Response to the Editor and Reviewers

Manuscript No.: egusphere-2026-1311

Title: Simulating the impacts of utility-scale photovoltaic installations with a physically based coupled WRF-PV model

Response to Reviewer 1

Figure R1: Annual diurnal cycles of the T2 difference between WRF_PV and WRF_CTL during 2018–2024, averaged over the PV grid cells in each year.

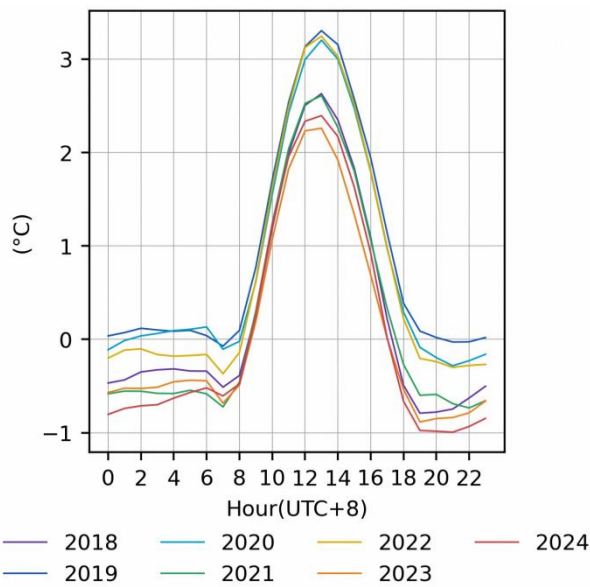
L231~232: Given that the PV area is different across the years, did you find slightly different results when only looking at individual years? Say, assume that the PV area was increasing in these years, can I

expect that PV-induced effect also increased with time? If so, this could be a piece of evidence that the difference seen in the results is indeed caused by PV panels instead of other meteorological factors.

Response: Thank you for this helpful suggestion. We examined the PV-induced responses separately for each year from 2018 to 2024. For T2, the response was calculated by averaging over the PV grid cells in each individual year. The annual results show a similar diurnal pattern, characterized by pronounced daytime warming and relatively weak nighttime changes (Fig. R1). The mean T2 response over PV grid cells did not increase monotonically with PV area. Moreover, the response of newly added PV farms may be affected by their latitude, elevation, and background circulation conditions. For precipitation, the median cumulative differences were generally comparable across years for both heavy precipitation and all precipitation intensities (Figs. R2 and R3). Among the seven years, 2024 showed a broader positive upper tail and comparatively large positive cumulative differences.

Figure R4: Land-use type of D03 in WRF_PV for the idealized experiment.

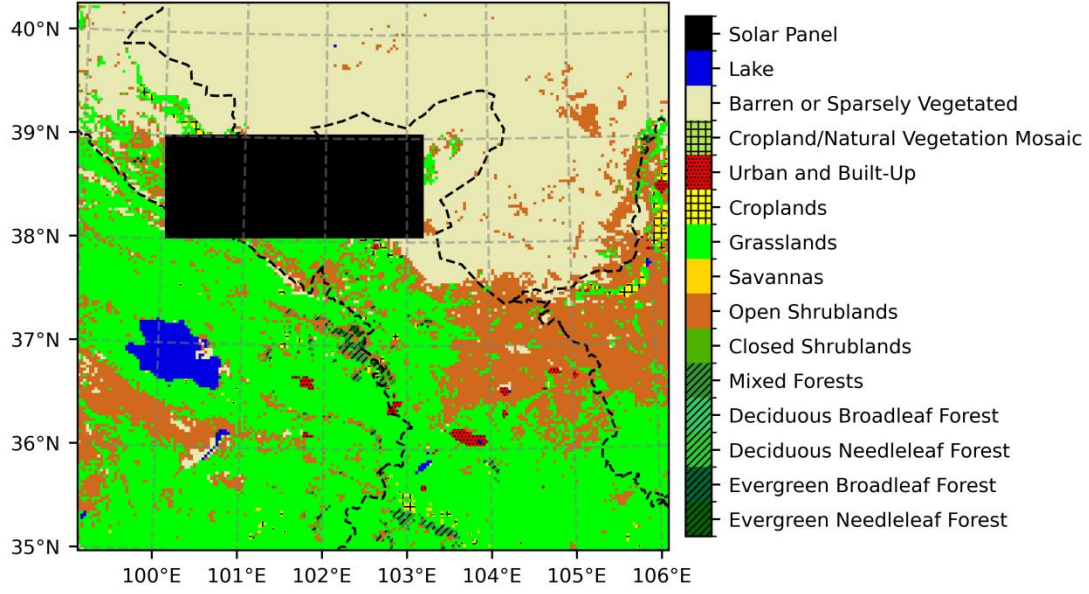
Section 4.4: I still doubt whether the differences are significant relative to the noise from internal variability and whether they are really induced by PV panels. I think the key question to answer is whether the described atmospheric feedbacks can be linked to the PV installations. Maybe the authors can try some sensitivity experiments. For example, in an extremely idealized case, what if a more concentrated region or even the whole region is covered by the solar farms? Will we see the same consistent patterns in Figures 9 and 10?

Response: Thank you for this constructive suggestion. Following this suggestion, we conducted an additional idealized three-member ensemble experiment for summer 2024. A large contiguous area in the northern part of D03 was prescribed as PV-covered, while the model configuration, simulation period, and 2024 meteorological boundary forcing were kept consistent with the original experiments (Fig. R4). The ensemble-mean summer precipitation increased over the northern part of the plateau and the southern part of the domain, while precipitation decreased mainly in the far north and southwest (Fig. R5a). For heavy precipitation exceeding 30 mm day^{-1} , positive cumulative differences occurred over the northeastern part of the plateau and parts of the Hexi Corridor (Fig. R5b). The precipitation frequency distribution also showed a clear enhancement of heavy precipitation (Fig. R5c).
